Bulletin | Danfoss Turbocor Compressors

B-CN-417-EN REV A

SUBJECT: VTX1600 Major Revision "C" Introduction

Figure 2 - Major Revision "C" VTX1600 Front View

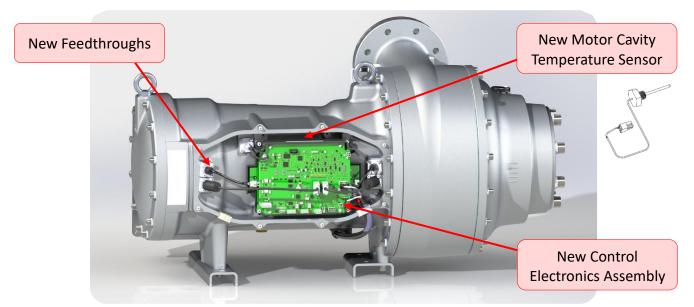
Major Revision "C" includes several improvements to optimize installation, performance, and service. These improvements include an integrated Cavity Temperature Sensor which eliminates the need for installation of the Cooling Exit Temperature Sensor, an optimized motor for improved thermal performance, the latest Danfoss ETS 5M expansion valve for Motor Cooling control, improved Bearing Sensor and Power Feedthrough designs, and a new firmware release (version 1.9).

Figure 4 - Motor Cavity Temperature Sensor

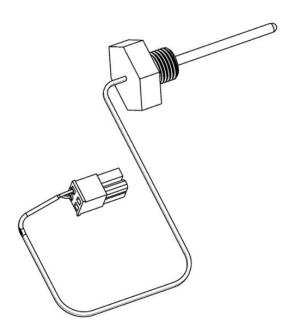
The Cooling Exit Temperature Sensor will be replaced by the same Cavity Temperature Sensor used for Turbocor TT/TG series products. This eliminates the need to install the Cooling Exit Temperature Sensor during compressor installation which was introduced with Bulletin B-CN-277-EN.

Note: The Motor Cooling Mode for Major Revision "C" VTX1600 compressors is set to "Cavity" by the factory. This setting should not be changed for Major Revision "C" compressors which use the Cavity Temperature Sensor. Major Revision "B" compressors using the Cooling Exit Temperature Sensor should continue to use Motor Cooling Mode "Aux Temp". **This is for information purposes only and requires no action from the customer.**

Figure 8 - VFD and VFD Control Card

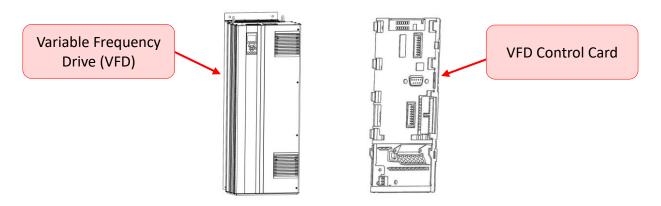
A new version of the VFD Control Card firmware, version 9.14, is being implemented into production according to the same timing as the VTX1600 Major Revision "C" launch.

As described in the preceding section, the Kinetic Backup functionality is not available when the compressor uses Firmware Version 1.9 and the VFD Control Card uses firmware version 9.12. When compressors in the field are upgraded to firmware version 1.9, upgrade the VFD Control Card to firmware version 9.14 to restore the Kinetic Backup functionality. VFD Control Cards with firmware version 9.14 are available for purchase as Spare Part Kit part number 199K2013.

All VTX1600 compressors leaving the Danfoss Turbocor factories will be shipped with firmware version 1.9, including Rebuilt Certified Compressors. If the Rebuilt Certified Compressor will be installed on an existing chiller where the VFD Control Card uses firmware version 9.12, Danfoss will provide a new VFD Control Card with the Rebuilt Certified Compressor free-of-charge so that the VFD can be upgraded. Please inform your Customer Experience Account Manager to ensure that this card is included with your order.
